Bulletin No: 98 DEM 1
Release Date: Sept. 21, 1998
Effective Date: Sept. 21, 1998
Supersedes:
Completion Date: Immediately
Page: 1 of 2

SERVICE BULLETIN

Ride Manufacturer: Zamperla Inc.	Affected Production Dates: All
Ride Name: Demolition Derby	Affected Serial Nos.: All
Model Number: Demolition Derby

FIG.1

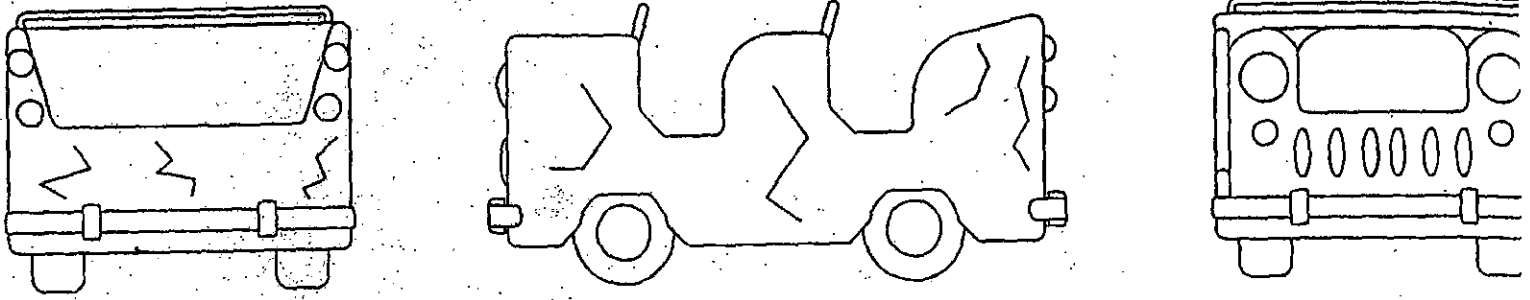
The seat belt restraint system employed does not effectively restrain the riders in the car seat.

Relocate the seat belt fastening position.

Remove the seat belt fasteners from the original mounting position. Attach the seat belt fasteners to a point in the lower left and right corners of the seat. Refer to the attached diagram (Page 2 of 2).
